# Brocade Fabric OS v5.0.5a Release Notes v1.0

July 19, 2006

**Figure 12-1** FICON CUP Management, Port Based Routing.

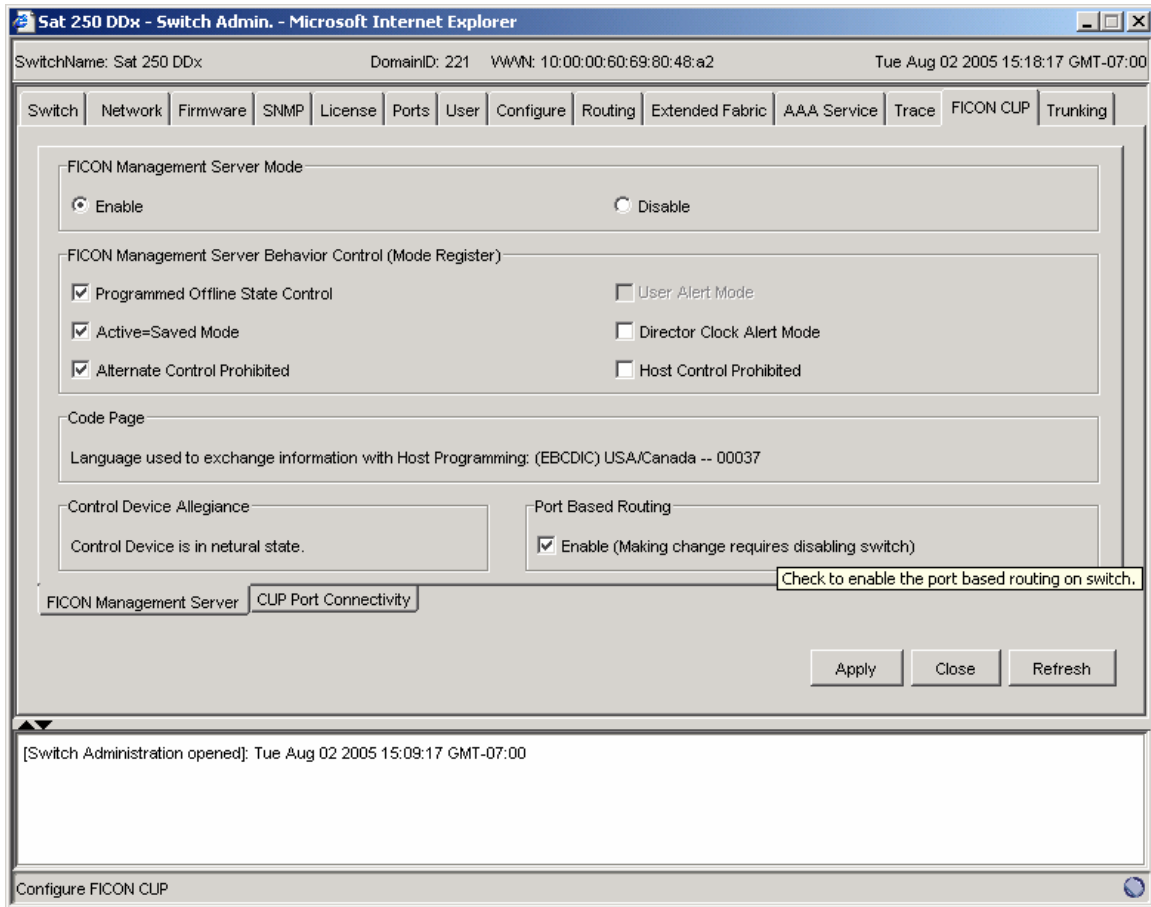
In Chapter 12, “Administering FICON CUP Fabrics,” on page 12-1, add a new section “Enabling Port Based Routing”

4. Click the **Enable** radio button to enable the port-based routing policy.

**Figure 14-1** Accessing Performance Graphs

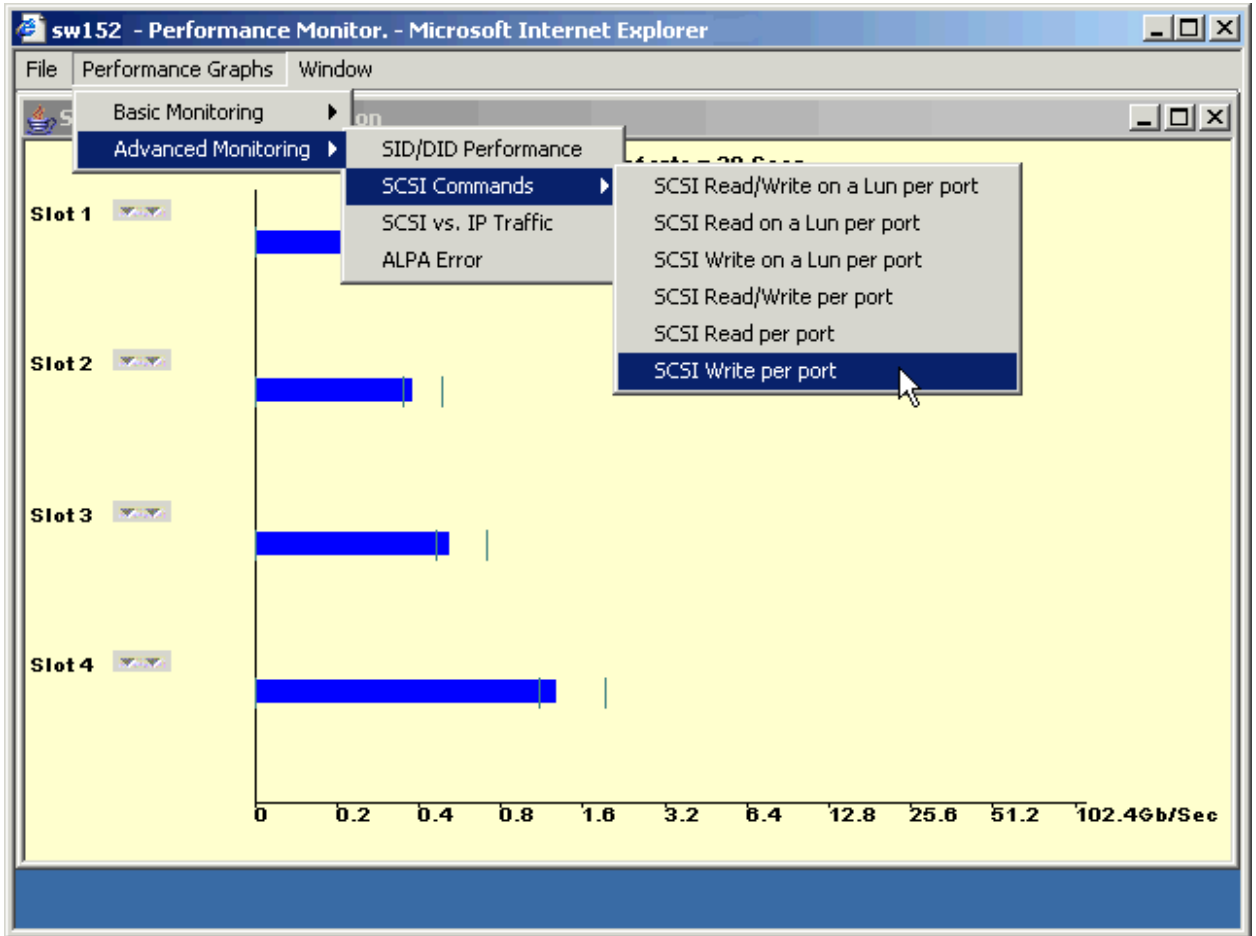
Port throughput utilization is represented by a horizontal bar for each selected port, which gets longer or shorter depending on the percent utilization for that port at the last poll time. Thin short vertical intersecting bars give a historical perspective by representing the highest and lowest values reached for each selected port since the graph was opened. A third bar between them represents the average of all values polled. (See Figure 14-1.)

On page 14-3, replace Figure 14-1 with this one:
